STAFF RECOMMENDATION 1813 Holly Street June 20, 2018

Metropolitan Historic Zoning Commission
Sunnyside in Sevier Park
3000 Granny White Pike
Nashville, Tennessee 37204
Telephone: (615) 862-7970
Fax: (615) 862-7974

Application: New construction— addition and outbuilding/DADU
District: Lockeland Springs-East End Neighborhood Conservation Zoning Overlay
Council District: 06
Map and Parcel Number: 08314001500
Applicant: Craig Kennedy, Bootstrap
Project Lead: jenny.warren@nashville.gov

Description of Project: Application is to construct a rear screened porch addition and a detached accessory dwelling unit (DADU). The DADU will be constructed four feet (4') from the screened porch.

SITE PLAN

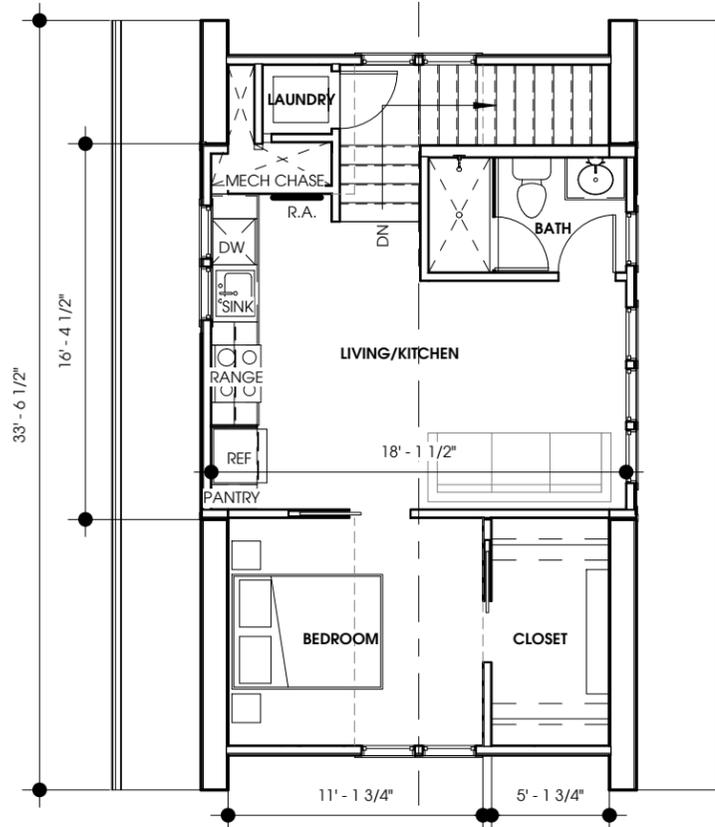
The proposed outbuilding has a footprint of six hundred and ninety-seven square feet (697sqft). For an outbuilding with a footprint of less than seven hundred square feet (700sqft), the setback requirements are as follows:

Minimum	Proposed
Rear Setback	5'	~36'
Right Side Setback	3'	3'
Left Side Setback	3'	~24'
Distance between principal building & outbuilding	20'	4'

The proposed location and setbacks are compatible with the setback requirements and meet Section II.B.8.b for location with the exception of the distance between the house and the outbuilding. The new screened porch and the proposed outbuilding will sit only four feet (4') apart. The guidelines call for a twenty foot (20') separation, though the Commission has reduced that to ten feet (10') for lots that are less than 150' deep or had other obstructions. In this instance, the property is subject to a sewer easement which makes the rear of the property unbuildable. The applicant has obtained a five foot (5') easement encroachment, but even so, cannot construct in the rear thirty-five feet (35') of the lot. This necessarily pushes the buildable area toward the rear of the existing house. Due to this site constraint, Staff finds that the reduced distance between the addition and the outbuilding may be appropriate. Further, this is the same location as the existing outbuilding, which has been on the property in some form since at least 1957. The location also aligns with the approximate location of other outbuildings in the vicinity.

ELEVATIONS

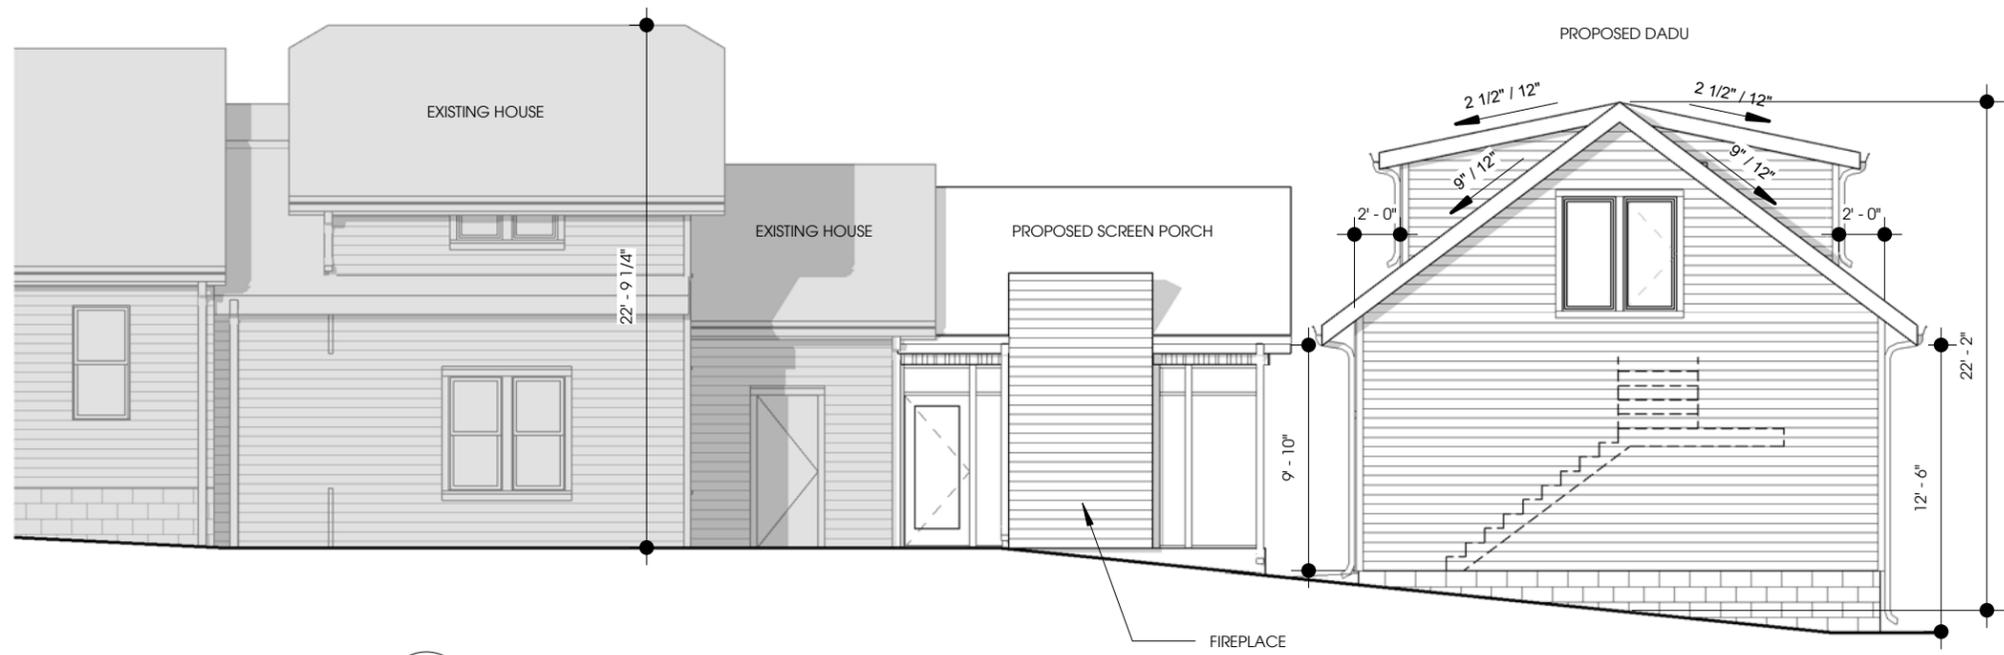
Design & Roof form: The proposed screened porch has a simple rectangular shape. It has a rear gabled roof form with a 7/12 slope which is compatible with the existing house.

The proposed materials are all appropriate with the exception of the lap siding on the fireplace. The Commission has required that fireplaces be masonry. With the condition that fireplace be masonry and that the door is administratively approved, staff finds that the known materials of the project will meet section II.B.10.e of the design guidelines.

Proposed Element	Proposed Form	Typical of district?
Primary form	Side gable	Yes
Primary roof slope	9/12	Yes
Dormer form	Shed	Yes
Dormer slope	2.5/12	Yes

The roof form and pitches are similar to historic outbuildings. The shed dormers are each less than 50% of the roof width and are set back two feet (2') in accordance with the design guidelines. The front dormer is nearly all glazing, as the Commission has required in the past. The rear dormer has less glazing than usual, however, as it faces the rear of the lot, Staff finds this condition to be appropriate. The project meets Section II.B.8.a of the design guidelines and section 17.16.030.G.8 of the ordinance.

1. The chimney on the screened porch shall be masonry;
2. Staff approve the final windows, garage door, pedestrian doors and the door on the screened porch prior to purchase and installation;
3. The HVAC unit for the outbuilding shall be located on the rear elevation or along a side elevation, beyond the midpoint of the building.
4. Staff receive a copy of the filed restrictive covenant for the detached accessory dwelling unit prior to issuance of a permit.
- 5.
